Comments on “Proposed NYISO Installed Capacity Demand Curves for the 2021-2022 Capability Year and Annual Update Methodology and Inputs for the 2022-2023, 2023-2024 and 2024-2025 Capability Years”

Submitted by the New York Transmission Owners

October 9, 2020

Fig. 1: Historical vs. Backcast Operation for Zone C Gas-Fired Plants, Using Dominion North and TGP Zone 4 (200L) Price Indices for Backcast Simulations

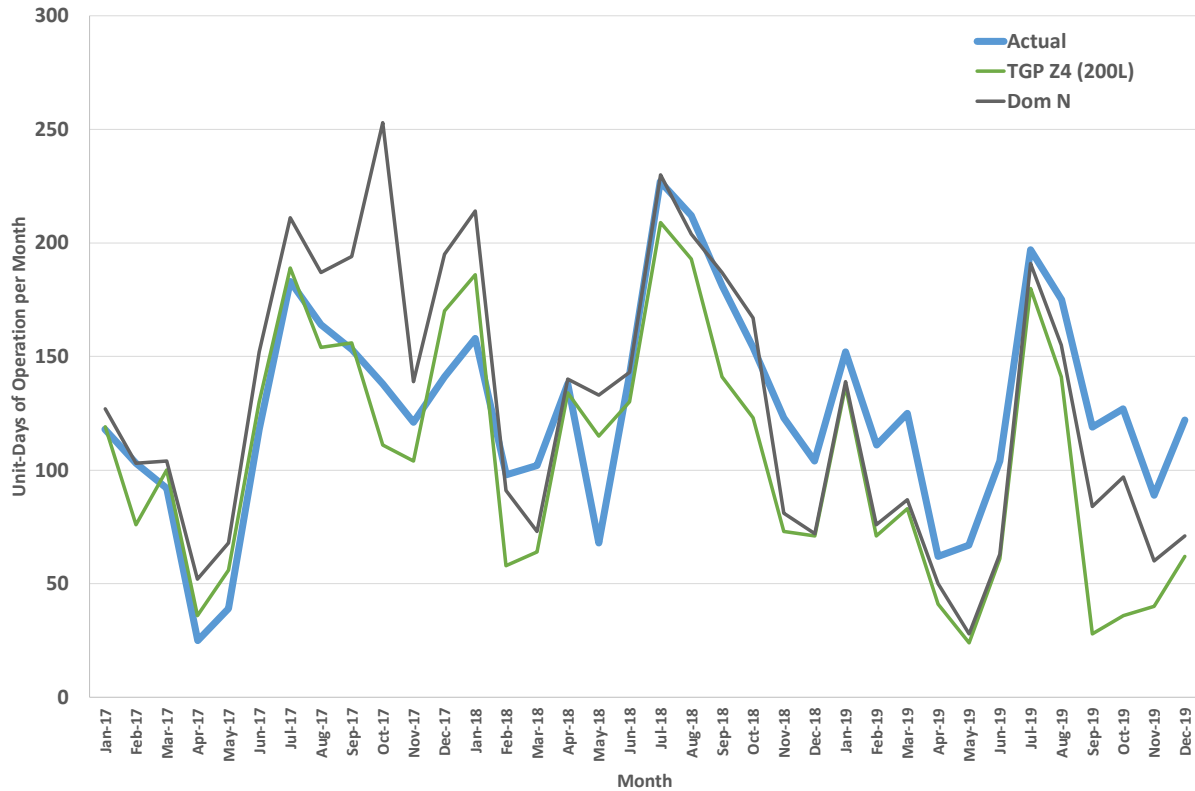
In a memo that accompanied the ISO Staff Recommendations, the MMU reported the results of additional analysis it conducted, which confirmed the consultant's conclusions that the Dominion North and TGP Zone 4 (200L) natural gas price indices better reflected the cost that a generator in Zone C would have incurred to purchase natural gas than the other price indices considered by the consultant.⁸ Fig. 1 compares the number of unit-days for which nine natural gas-fired units in Zone C actually operated during 2017, 2018 and 2019 to the number of unit-days for which those units would have operated in the MMU's backcast simulations, using either the Dominion North or TGP Zone 4 (200L) price indices (plus a transportation adder) to indicate the cost of natural gas.⁹ As it shows, the backcast simulation using the Dominion North price index very closely approximated the actual operation of these units: while they actually operated for 4,552 unit-days, they operated for 4,621 unit-days in the backcast simulation that used the Dominion North price index. While it did not match actual operation as well as the Dominion North backcast simulation, the backcast simulation using the TGP Zone 4 (200L) price index also corresponded reasonably well to actual operations, as these units ran for 3,802 unit-days in the backcast simulation that used the TGP Zone 4 (200L) price index.

Fig. 2: Historical vs. Backcast Operation for Zone C Gas-Fired Plants, Using TGP Zone 6 and Iroquois Zone 2 Price Indices for Backcast Simulations

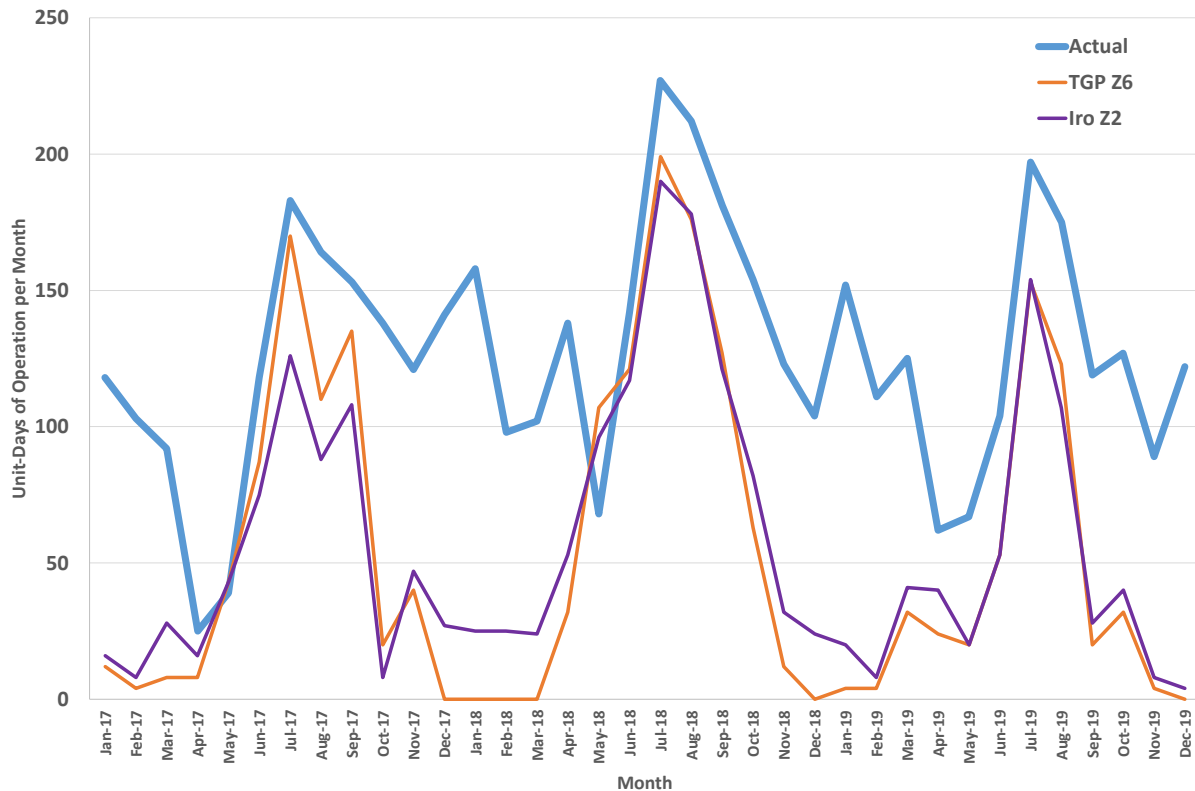
Fig. 2 compares the number of unit-days for these natural gas-fired units in Zone C actually operated during 2017, 2018 and 2019 to the number of unit-days for which those units would have operated in the MMU’s backcast simulations, using either the TGP Zone 6 or Iroquois Zone 2 price indices (plus a transportation adder) to indicate the cost of natural gas. As it shows, the backcast simulation using either of these natural gas indices did not closely reflect the actual operation of these units: they operated for only 1,943 unit-days in the backcast simulation that used the TGP Zone 6 price index and for only 2,080 unit-days in the backcast simulation that used the Iroquois Zone 2 price index, each of which is less than half of the 4,552 unit-days for which those units actually operated. The largest differences are in the winter. In reality, these units often operated during the winter, but they would have only rarely operated during the winter in the backcast simulations using either the TGP Zone 6 or Iroquois Zone 2 natural gas price indices. Therefore, using the TGP Zone 6 or Iroquois Zone 2 natural gas price indices would have caused net EAS revenue to be understated significantly and would misrepresent the natural gas price paid by the Zone C proxy unit.

Fig. 3: Historical vs. Backcast Operation for Zone C Gas-Fired Plants in Dec. through March, Using TGP Zone 4 (200L) Price Index for Backcast Simulation

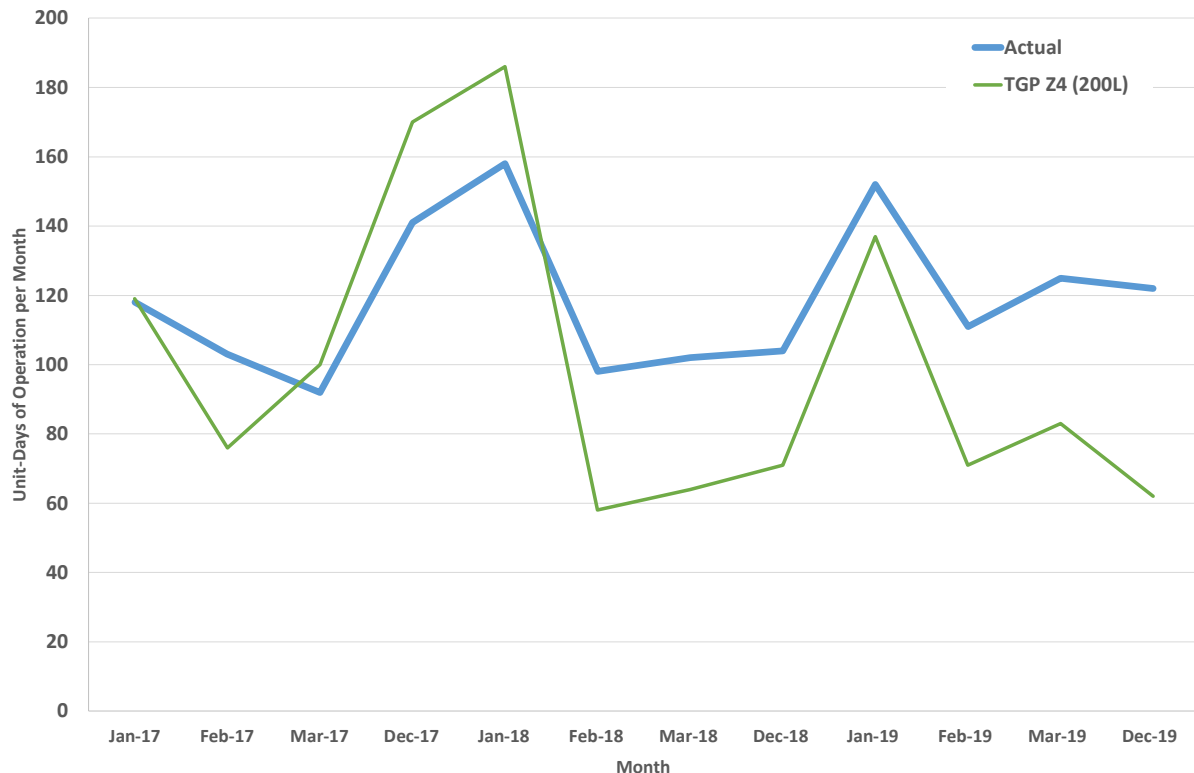
The MMU then went on to propose that the ISO should use prices at the Niagara natural gas hub for the months of December through March, while using the TGP Zone 4 (200L) natural gas price index for only the eight remaining months of the year.¹⁰ It is difficult to understand the basis for this MMU recommendation. Inexplicably, even though the MMU recommended its use, the MMU did not include the Niagara natural gas price index in its backcast simulations, which were intended to assess whether each of the proposed natural gas price indices reasonably reflected the actual natural gas costs for generators in Zone C. But we can infer something about the results of such a simulation by comparing the number of unit-days that the nine Zone C natural gas-fired units actually operated to the number of unit-days during which those units would have operated in the backcast simulation using the TGP Zone 4 (200L) price during only the months of January, February, March, and December—i.e., the months for which the MMU recommended that the ISO use the Niagara natural gas price index instead of the TGP Zone 4 (200L) natural gas price index. Fig. 3 presents that comparison. As it shows:

- In one month (January 2017), those Zone C natural gas-fired units actually operated for approximately the same number of unit-days as in the TGP Zone 4 (200L) backcast simulation.

- In three months (March 2017, December 2017 and January 2018), those Zone C natural gas-fired units actually operated for fewer unit-days than in the TGP Zone 4 (200L) backcast simulation.
- In the remaining eight months (February 2017; February, March and December 2018; and January, February, March and December 2019), those Zone C natural gas-fired units actually operated for more unit-days than in the TGP Zone 4 (200L) backcast simulation.

In total, the Zone C natural gas-fired generators actually operated for 1,426 unit-days, compared to 1,197 unit-days in the MMU’s TGP Zone 4 (200L) backcast simulation.¹¹ Because the Niagara natural gas price index is usually higher than the TGP Zone 4 (200L) natural gas price index during the four winter months of December through March,¹² a backcast simulation based on the higher priced Niagara natural gas price index would result in a **decrease** in the number of unit-days that the Zone C natural gas-fired generators

ran when compared to the MMU's TGP Zone 4 (200L) backcast simulation. Consequently, using the Niagara natural gas price index during the four winter months of December through March would **increase** the divergence between the number of unit-days that the Zone C natural gas-fired generators actually operated and the number of unit-days these generators would have operated in the backcast simulation. Therefore, the MMU's backcast simulation approach shows that it is inappropriate to use the Niagara natural gas price index, instead of the TGP Zone 4 (200L) natural gas price index, to estimate the natural gas fuel cost for Zone C generators during the four winter months of December through March.

of that lateness, and the evidence offered here to indicate that there is significant doubt as to whether this MMU proposal is justified, the Board should direct ISO staff to revise its recommendation and use either the TGP Zone 4 (200L) natural gas price index or, preferably, the Dominion North natural gas price index for the Zone C proxy unit for all twelve months of the year.

Fig. 4: Deal Count and Trade Volumes at Various Gas Hubs During December through March

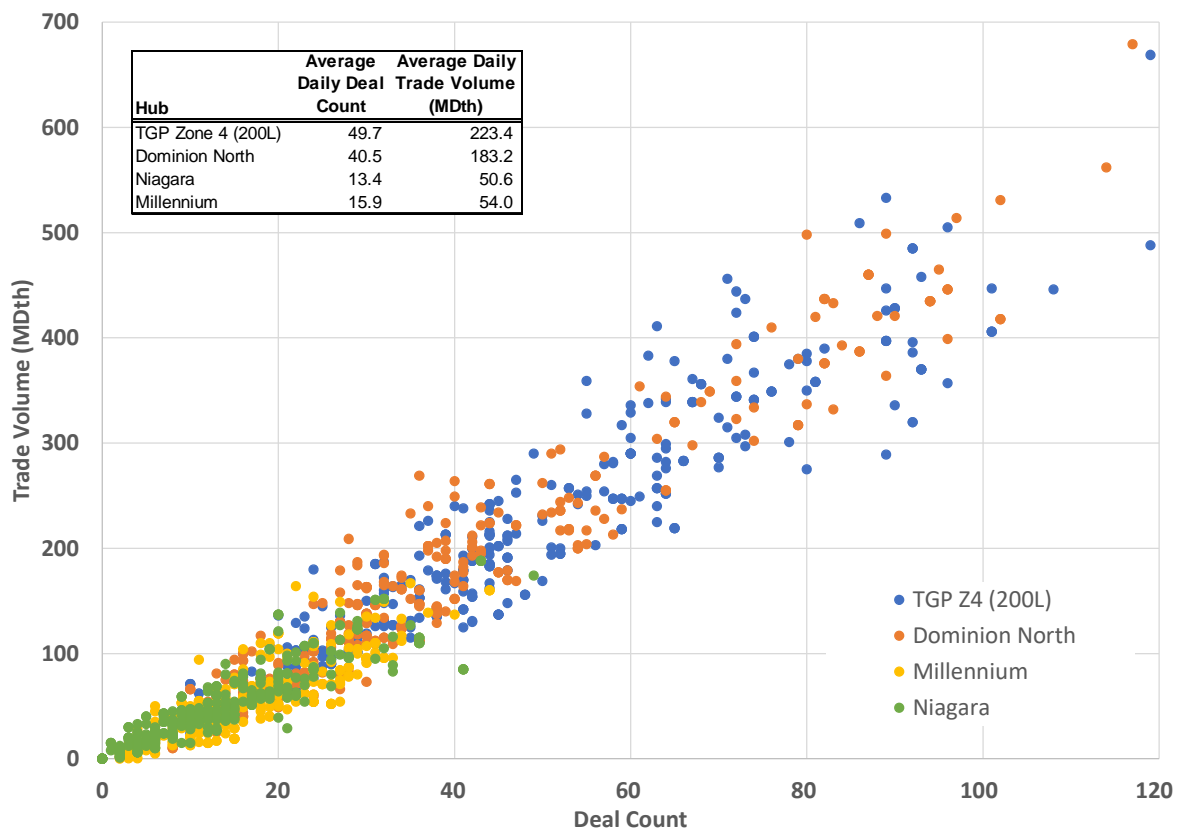
However, Platts has informed the TOs that on 37 instances over the last three winters (i.e., about ten percent of the time), Platts did not publish a price for the Niagara natural gas price index, whereas Platts publishes a price for the Dominion North and TGP Zone 4 (200L) natural gas price indices for almost every trading session. That calls into question whether the Niagara natural gas price index is sufficiently reliable for use in the DCR, particularly since ISO staff accepted its consultant's recommendation **not** to use the Millennium natural gas price index for a proxy unit in Zone G because the Millennium gas hub "lacks historic trading volume, which raises concerns in regards to liquidity."¹⁵ Liquidity at a given gas hub can be measured either by the "deal count" at that gas hub, or the total volume of natural gas traded at that gas hub. Fig. 4 consists of a scatter diagram, which shows the deal count and total volume traded at the Dominion North, TGP Zone 4 (200L), Niagara and Millennium gas hubs for each day during the months of December through March (i.e., the months for which ISO staff proposes to use the Niagara natural gas price index) over the last three years.¹⁶ As it clearly shows, the Niagara gas hub is much less liquid than either the Dominion North gas hub or the TGP Zone 4 (200L) gas hub, whether measured by deal count or by average volume traded. Liquidity at the Niagara gas hub during those months is similar to (although slightly worse than) the liquidity at the Millennium gas hub.¹⁷ Consequently, the TOs do not

understand how ISO staff reached the conclusion that it is reasonable to use the Niagara natural gas price index for Zone C during the winter months despite the lack of liquidity due to inadequate trading volume, after having previously concluded that lack of liquidity due to inadequate trading volume was sufficient reason to disqualify the Millennium natural gas price index, even though liquidity at the Millennium gas hub is better than liquidity at the Niagara gas hub. If the ISO is concerned that prices at the Millennium gas hub are not reliable enough for use in the DCR, or that it needed to use a natural gas price index that is more likely to be available than the Millennium natural gas price index, the ISO should be even more concerned about the reliability and availability of the prices at the Niagara gas hub.

Fig. 5: Map of Ozone Non-Attainment Zones

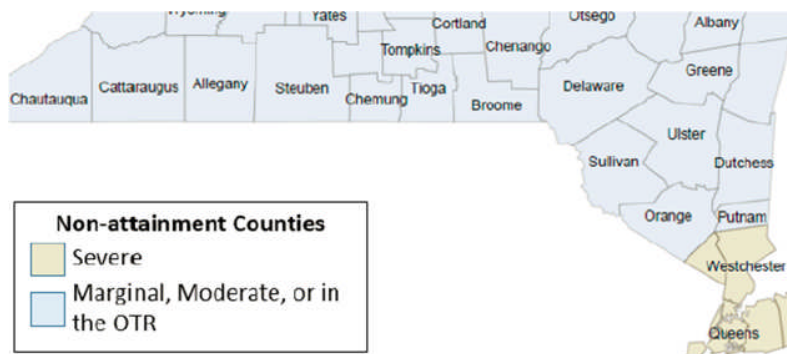
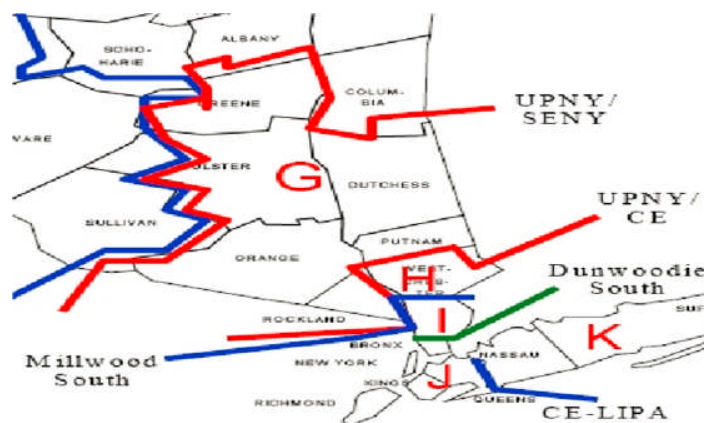
without back-end emissions control technology. Within this context, a potentially relevant consideration is that the lower Hudson Valley also contains severe non-attainment areas and that selecting a plant without SCR emissions controls would not accommodate potential new plants throughout the region.”²⁵ First, assuming that it would be necessary for generating units in Dutchess County to conform to emissions requirements that do not actually apply to Dutchess County would be speculative and inconsistent with the approach taken in other aspects of the DCR, which intends to limit the extent to which the ISO relies on unverifiable assumptions.²⁶ Second, as shown by Fig. 5 (which shows the relevant portion of the severe ozone non-attainment zones) and Fig. 6 (which shows the six counties located in Zone G), Rockland County is the only county in Zone G that is inside the severe ozone non-attainment zone. Dutchess County and the other counties in Zone G (Greene County, Ulster County, Orange County, and Putnam County) are all outside of the severe ozone non-attainment area, so selecting a plant without SCR would accommodate a generator in any of those counties.

Consequently, the Board should direct ISO staff to remove the unjustified assumption to include the SCR cost for the H class frame generator built in Dutchess County. If, after doing so, an H class frame generator in Dutchess County without SCR continues to yield a lower MRP than would result from the use of an H class frame generator in Rockland County with SCR, then the demand curve that the ISO files for the G-J Locality should reflect the amount of capacity revenue that would be required to support development of an H class frame generator in Dutchess County without SCR.

Fig. 7: Map of Natural Gas Pipelines in Zone G

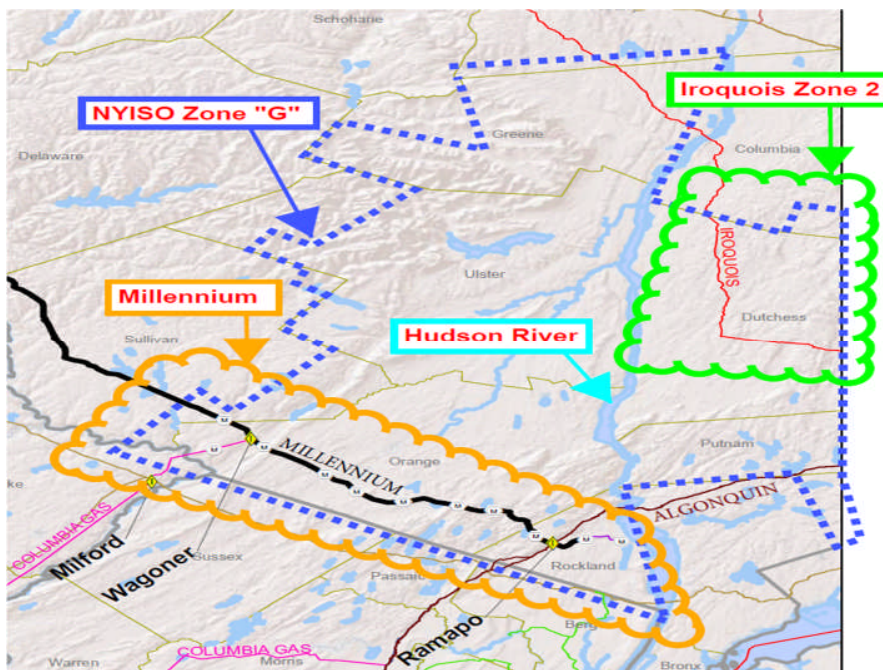
As Fig. 7 shows, Zone G is bisected by the Hudson River. Marcellus shale natural gas is more directly available on the west side of the Hudson River than on the east side of the Hudson River. This causes the natural gas price on the west side of the Hudson River (where Rockland County is located) to be lower than the natural gas prices on the east side of the Hudson River (where Dutchess County is located). For this reason, it is important to select natural gas price indices for generators in Rockland County and in Dutchess County that reasonably reflect the price of natural gas in each location. Based on our discussions with natural gas sellers, we conclude that the natural gas price indices that ISO Staff adopted for Rockland County and for Dutchess County (TETCO M3 natural gas price index for the former and Iroquois Zone 2 natural gas price index for the latter³⁴) reasonably and fairly represent the cost of natural gas purchased at these locations.

Fig. 8: Map of Algonquin Pipeline in Rockland County and Adjoining Counties

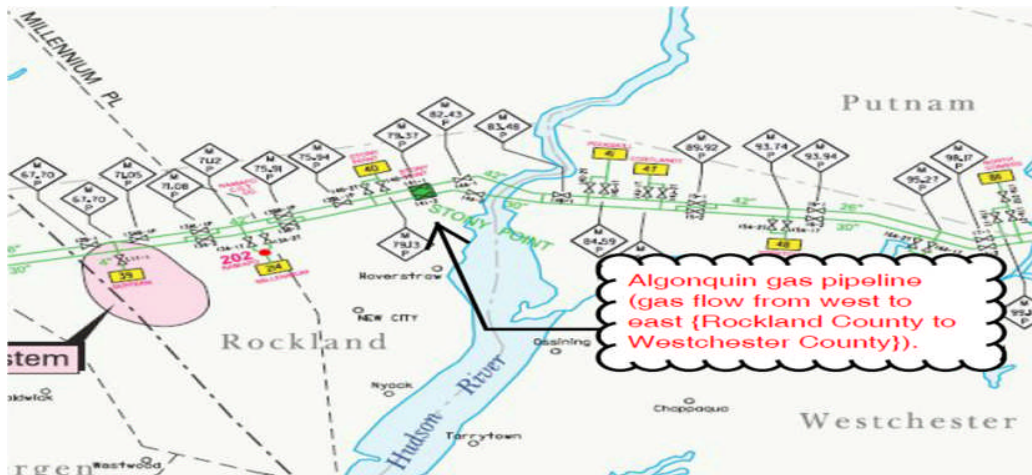
The MMU also analyzed this issue, pointing out that the Algonquin pipeline could be used in a similar manner. It stated, “Pipeline data supports the finding that gas transported from the TETCO M3 zone via [the] Algonquin [pipeline] is available in Rockland County.... In 2019, Algonquin announced restrictions on interruptible nominations sourced from points west of its Stony Point Compressor Station for delivery east of Stony Point on 363 days, but did not announce restrictions on west-to-east transport for delivery west of Stony Point on any days. Stony Point is located on the west shore of the Hudson River at the eastern border of Rockland County.... Hence, while transport on Algonquin is frequently restricted, the main bottlenecks are located downstream. Transport to points in Rockland County such as the interconnect with Millennium Pipeline at Ramapo is generally available.”³⁶ Fig. 8 shows the relevant portion of the Algonquin pipeline. Together, these analyses demonstrate that it is reasonable to use the TETCO M3 natural gas price index for a generator located in Rockland County.³⁷
